PUBLIC INTEREST REVIEW FOR GROUND WATER APPLICATIONS

TO: Water Rights Section Date August 13, 2009
 FROM: Ground Water/Hydrology Section Marc Norton
Reviewer's Name
 SUBJECT: Application G- 17027 Supersedes review of June 30, 2008
Date of Review(s)

A. GENERAL INFORMATION: Applicant's Name: Kevin & Carrie Duyck County: Washington

Ground Water Levels Near Application G-17027 01N/03W-4

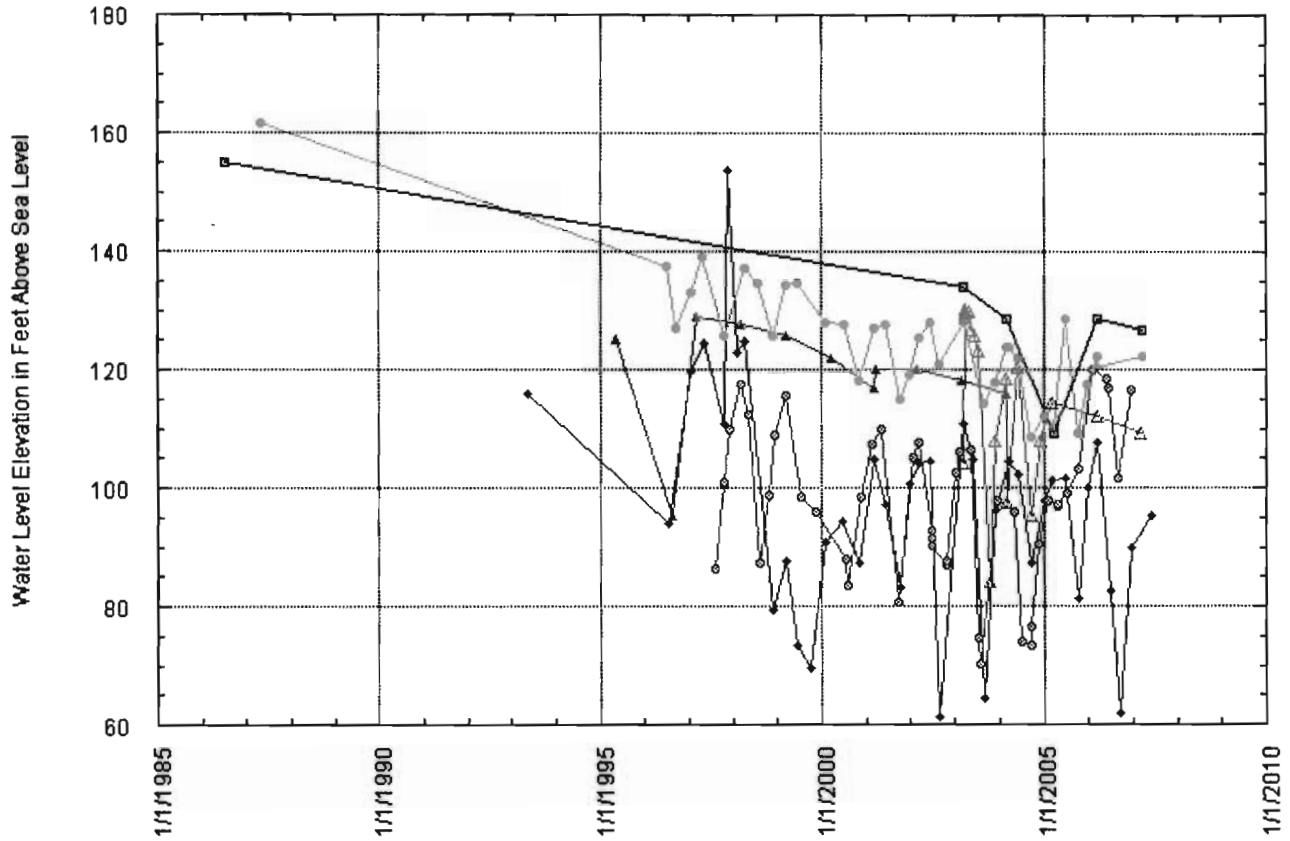
A4. **Comments: See conceptual model discussion for more details on geology and ground water. A review of well logs near the proposed property that develop water from the CRBG show yields considerably less than the amount requested.**

B3. Ground water availability remarks: The applicant has proposed one well that will produce from water-bearing zones in the Columbia River Basalt Group (CRBG). The CRBG consists of a series of lava flows that range up to 300 feet thick in the vicinity of the proposed wells. Although unconfined ground water occurs near the surface of the basalts, most water occurs in confined aquifers that occupy thin rubble zones (interflow zones) that occur at the contacts between lava flows. The thick interiors of the basalt flows generally have very low porosity and permeability and act as confining beds. This physical geometry generally produces a stack of thin aquifers (interflow zones) separated by thick confining beds (flow interiors). In the area of the proposed wells, the basalt aquifers are truncated by local stream drainages which have eroded to various levels through the basalt column (see attached map). Because the aquifers are confined (storativity is estimated to be 0.0001), pumping impacts will propagate outward at rapid rates and are likely to reach aquifer boundaries (streams, faults, and truncated basalt flow margins) within a few hours. Using aquifer parameters appropriate for the basalts, it can be shown that the cone of depression from a pumped well will produce measurable impacts at a distance of 1 mile within several hours. Therefore, hydraulic interference with nearby wells will occur rapidly once pumping begins. The presence of local aquifer boundaries will increase the degree of interference with nearby wells that are completed in the same water-bearing zones. Because of the limited size and low storage capacity of the basalt aquifers in the area, water will not likely be available within the capacity of the resource at the requested rate and the aquifers are unlikely to provide a long-term sustainable supply of water for large-volume use. Higher production rates may be likely if the wells are completed in multiple aquifers but commingling is not likely to affect the long-term sustainability of the basalt ground-water system because of low overall storage and local aquifer boundaries. Yields in wells completed to a depth as proposed are considerably less than requested. Yields in wells to the south are higher, but the wells develop water considerably deeper which are showing signs of overdraft. Ground water levels in wells to the north and south are showing declines. Water levels near the proposed site are not showing the declines as seen at other wells, but yields are such that overdraft is probable with the proposed development.

- i. The permit should contain condition #(s) 7B - Interference, 7I - Willamette Basalt, 7P - Well Tag + large monitoring and reporting with flow meter requirement;
